**Posted for Public Notice: March 16, 2022**

## **City of Bend Standards and Specs Summary of Changes via Technical Amendment**

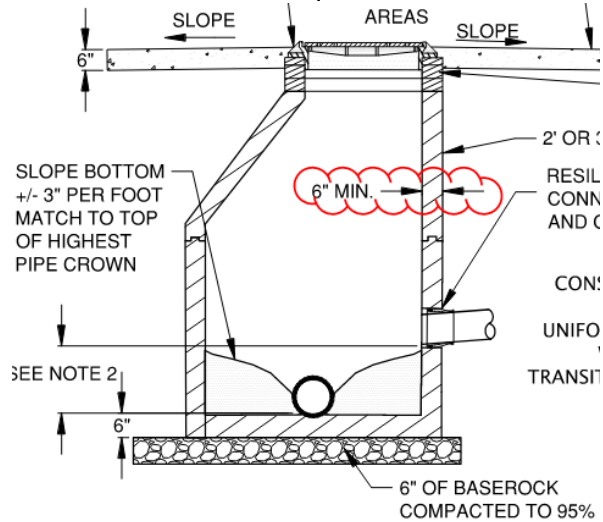
- Changed style of Romac saddle to be used
